INNER WEST COUNCIL

DEVELOPMENT ASSESSMENT REPORT

Application No.	DA201900038
Address	1/2C Gladstone Street, Newtown
Proposal	To demolish part of the premises and carry out ground and first floor alterations and additions to the building and use the premises as a brewery and restaurant operating 7:00am to 10:00pm daily
Date of Lodgement	7 February 2019
Applicant	Samcourt Pty Ltd
Owner	Samcourt Pty Ltd
Number of Submissions	33 (31 in objection, 2 in support)
Value of works	\$3,100,825
Reason for determination at Planning Panel	Number of submissions
Main Issues	Solar access Urban design Tree removal Car parking Hours of operation
Recommendation	Deferred commencement approval
Attachment A	Recommended conditions of consent
Attachment B	Plans of proposed development
Attachment C	Plan of Management
Attachment D	Acoustic Report

Figure 1: Indicative location of increased setback and landscaping required by recommended condition of consent.

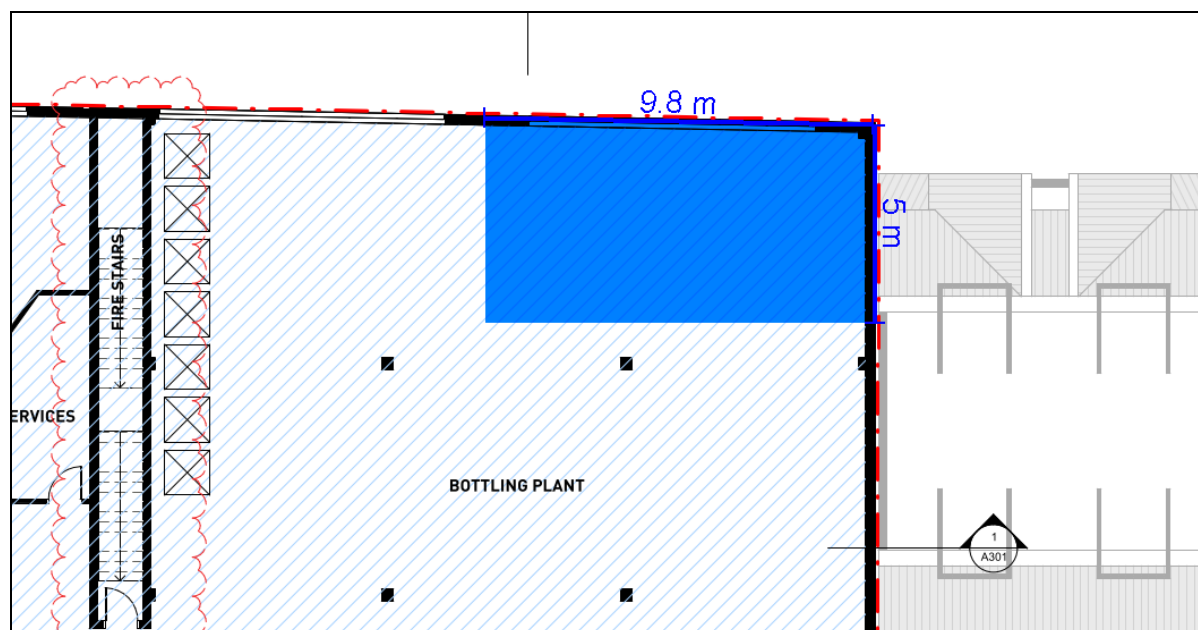
The application proposes a two storey building wall with a nil setback to each boundary. As noted above, a number of trees are currently located at the eastern corner of the property within the site frontage provide a visual buffer between the existing industrial building and adjoining dwellings to the east. The proposed removal of the existing vegetation together with the proposed setback to the Gladstone Street frontage is not considered acceptable as an appropriate buffer at the interface between the proposed development and the adjoining site.

As such, it is recommended that a condition be included in the development consent that requires the first floor building line to be setback 5 metres from the primary frontage and 9.8 metres from the eastern side boundary, as indicated in Figure 1 below, with a landscaped area to be provided at the first floor to provide a visual buffer between the two uses.

The 5 metre setback depth is recommended as it generally aligns with the top floor dormer windows of the neighbouring units, which offers visual continuity within the streetscape. The setback also provides adequate space for substantial tree growth; a lesser setback would not provide appropriate conditions for trees to grow to an adequate size that would assist in creating a visual buffer between the two sites. Additionally, the 9.8 metre setback width positions the 'cut-out' element between the two window proposed on this section of the elevation, which allows the proposed building façade design and proportions to be retained.

This condition will provide visual articulation and reduce with bulk and scale of the proposal at the sensitive industrial-residential interface. The proposal achieves the relevant objectives and controls of MDCP 2011 and can be supported in this regard.

- i) The north-east corner of the building at the first floor must be provided with an amended setback that measures 5 metres from the Gladstone Street front boundary, and 9.8 metres from the eastern side boundary.
- ii) The relocated north-facing wall may be provided with a window as proposed in the approved architectural plans. The relocated east-facing wall may also be provided with a similar window, or alternatively the wall must be solid (the provision of an access door/hatch) for maintenance is acceptable.
- iii) The 'cut-out' area created by the amended setback must be provided with landscaping on the roof of the ground floor in accordance with B below.
